Access Compliance Report

Public Rights-of-Way

Intersection ID: N/A	Main Street: OLD_CONCORD_RD	Cross Street: ORCHID_BRIDGE_RD	Location: SW
ADA ID: 2623ADFF2D4F	Ramp Type: Perp	Initial Pass/Fail: Fail	Overall Compliance: No
Codes/Mitigation Info/Possible Solution		Field Measurements/Component Compliance	
Severity Score: 1.25

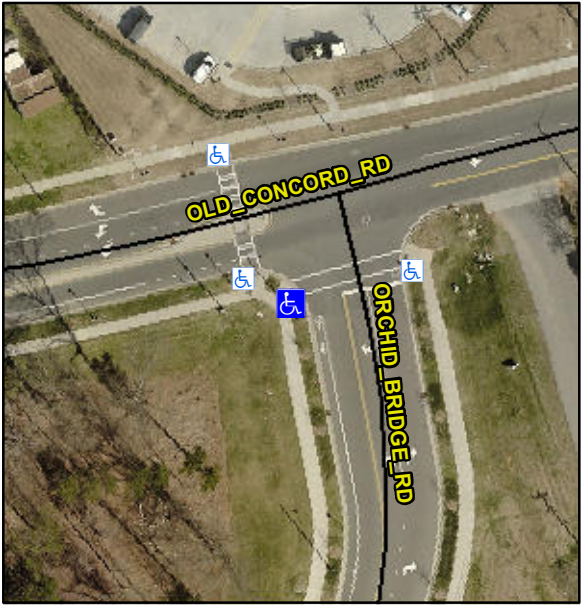
X Walk 1 X Slope (%)	3.6	
				N/A	Ramp inside XWalk1?	Yes	N/A
					Road Slope (%)	N/A	N/A
					Road X Slope (%)	N/A	N/A
				N/A	Any Obstructions?	N/A	N/A
					Obstruction Type		
						N/A	N/A
				Yes	Surface Condition? (G/P)		Good

Possible Solutions:						
	Remove & Replace Entire Ramp.						
	Surveyor Notes:						
	N/A						
	PROW/ADA:						
	R304.5.3						
	Street 1 Name	ORCHID BRIDGE RD					
	Stop Condition-Street 2	StopSign					
	Street 2 Name	N/A					
	Stop Condition-Street 1	N/A					
Total Cost:		\$ 1850.00					
				Compliance	Description	Data	Compliance
				Description			Description
				Data			Data
				N/A	Ramp Length (in)	97.0	Yes
				Yes	Ramp Width (in)	48.0	No
				N/A	Flare Type LT	N/A	N/A
				N/A	Flare Slope LT (%)	N/A	N/A
				N/A	Flare Traversable LT?	N/A	N/A
				N/A	Landing Length (in)	N/A	N/A
				N/A	Landing Width (in)	N/A	N/A
				N/A	Landing Slope (%)	N/A	N/A
				N/A	Landing X Slope (%)	N/A	N/A
				N/A	Landing Curb? (Y/N)	N/A	N/A
				N/A	Shared Landing?	N/A	
				N/A	Gutter Ponding?	N/A	N/A
				N/A	Gutter Lip Ht (in)	N/A	N/A
				N/A	Painted X Walk1?	Yes	N/A
					X Walk 1 Direction	To E	
				N/A	X Walk 1 Width (in)	94.0	N/A
					X Walk 1 Slope (%)	1.0
